THE  STAR

MODIFICATION 13 PLANNING SUBMISSION

AIR QUALITY AND MECHANICAL
SERVICES REPORT –
RESPONSE TO SUBMISSIONS

TO: Whom it may concern
FROM: Giancarlo Oradini
SUBJECT: **Air Quality and Mechanical Services Reports for Modifications 13 Planning Submission – Response to Submissions**
OUR REF: 181105-The Star-Mod 13-Mech-Air Quality_Response to Submissions rev04.docx
DATE: **5 November 2018**

Figure 1 Level 03 Plan view - New Darling Union and Edward Streets F&B exhaust discharge location.

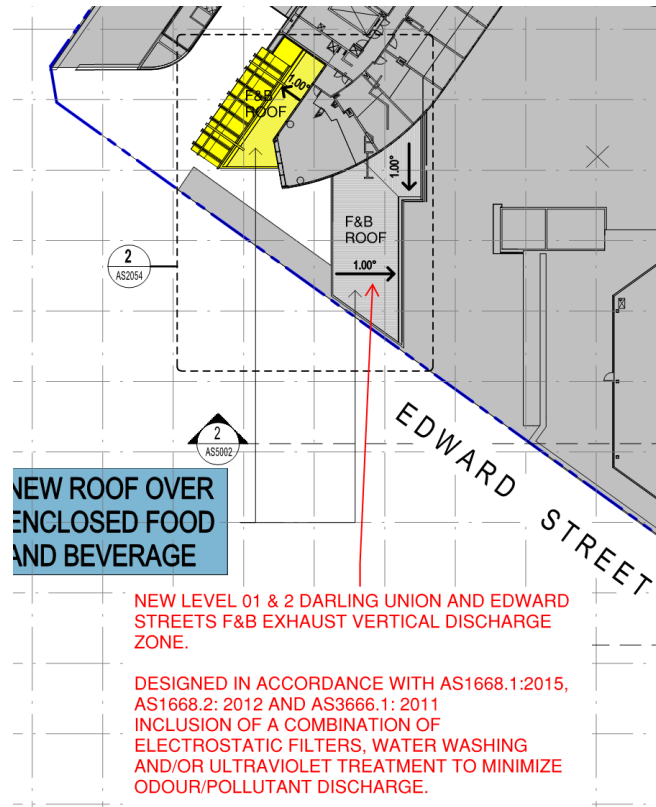
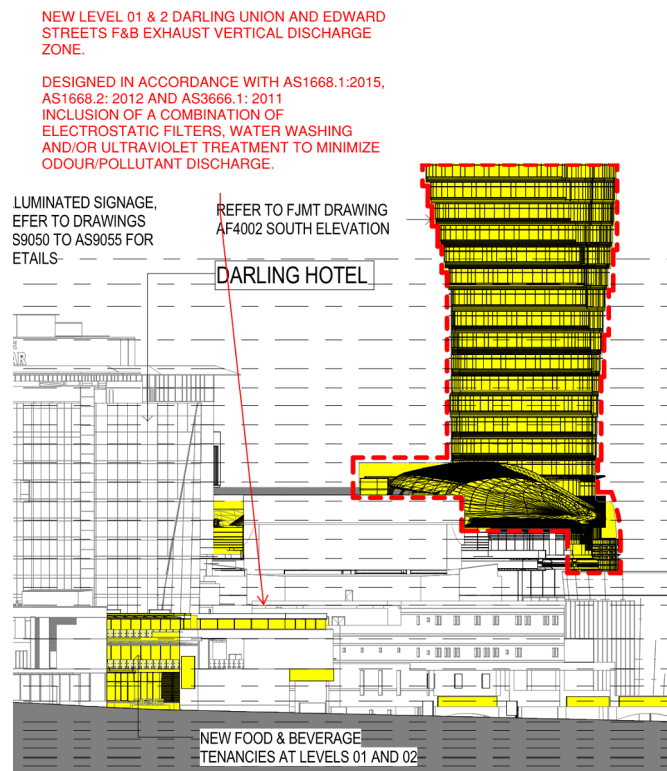
Exacerbated odour impacts on our client's enjoyment of their residences will occur due to the intensification of uses in The Star development and increases in building proximity

For clarity, we have identified the kitchen exhaust discharges on the architectural plans (extracts below):

- For new Darling Union and Edward Streets F&B,
 - Refer to DWP drawing, MOD13-AS1003 and MOD13-AS4002.
- For existing Level 01 MGF F&B, Level 05 Bistro, Residential Entrance Level Restaurant (Level 00) and New Restaurant Street Level 00
 - Refer to FJMT drawing, AF1006
 - Refer to DWP drawing, MOD13-AS4001
- For Level 5 Sky Terrace Restaurants, Level 7 F&B, Existing Level 00 F&B and Level 02 Nightclub
 - Refer to FJMT drawing, AF1008
 - Refer to DWP drawing, MOD13-AS4001
- For existing MUEF kitchen exhaust and relocated diesel generator flues,
 - Refer to DWP drawing, MOD13-AS1009 and MOD13-AS4002
